ADDENDUM # 3

RFP # 7550249

TITLE: CONSTRUCTION OF NEW WILDLIFE CENTER, EXETER

State of Rhode Island Department of Administration Division of Purchasing RFP# 7550249
CONSTRUCTION OF THE ARCADIA NATURAL RESOURCE VISITOR CENTER, DEM

9 PRECAST CONCRETE LIGHT BOLLARD
SCALE: 1" = 1'-0"

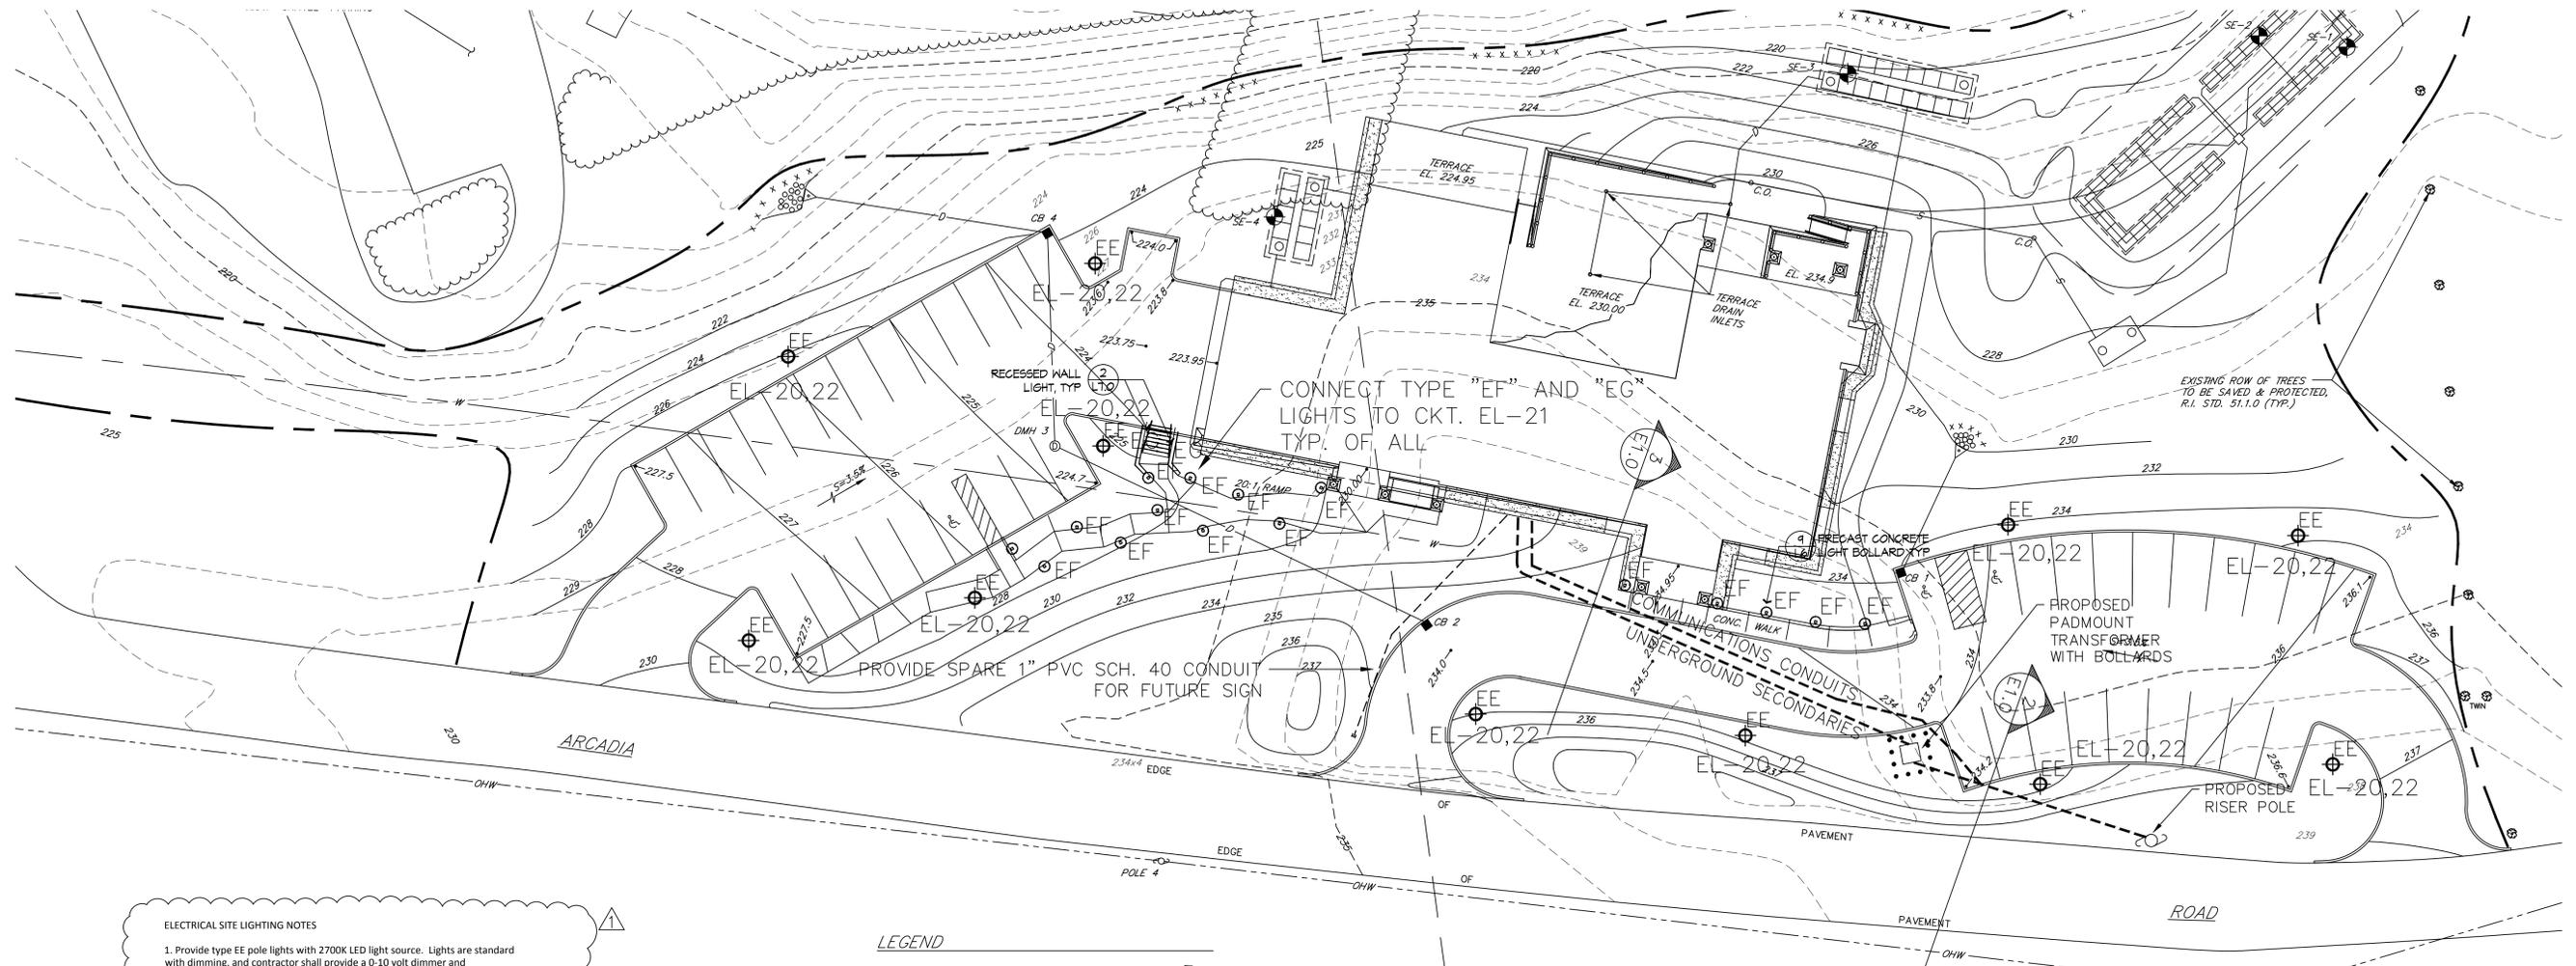
1. Provide type EE pole lights with 2700K LED light source. Lights are standard with dimming, and contractor shall provide a 0-10 volt dimmer and conduit/wiring as required. Locate dimmer in electrical room.
2. Contractor shall provide a separate 0-10 volt dimmer, wiring/conduit as required, for type "EF" and type "EG" lights. Locate dimmer in electrical room.
